DOCUMENT NO. 00 00 01

ADDENDUM NO. 1

**ALAMOSA WASTEWATER TREATMENT FACILITY
OUTFALL RELOCATION PROJECT
CITY OF ALAMOSA, COLORADO
TZA Project No. 0417001.02
September 28, 2018**

**ATTACHMENT ADD. NO. 1-8:
THRUST BLOCK DETAIL (END AND SIDE VIEWS)**

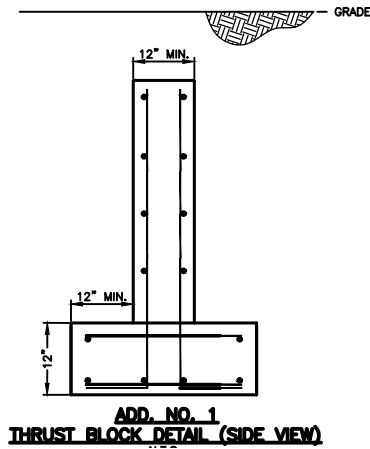
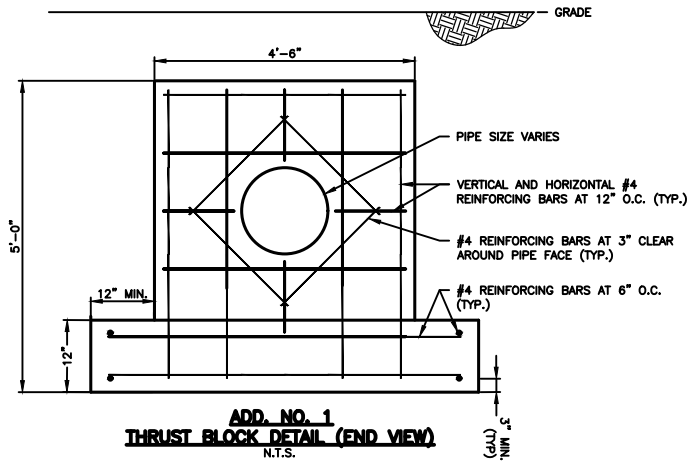
WWTP Outfall Relocation Plan Set: Drawing 7 of 7 – Details
a. **REPLACE** Thrust Block Detail (End View) with the attached detail:

Add. No. 1-8: Add. No. 1 Thrust Block Detail (end and side views)
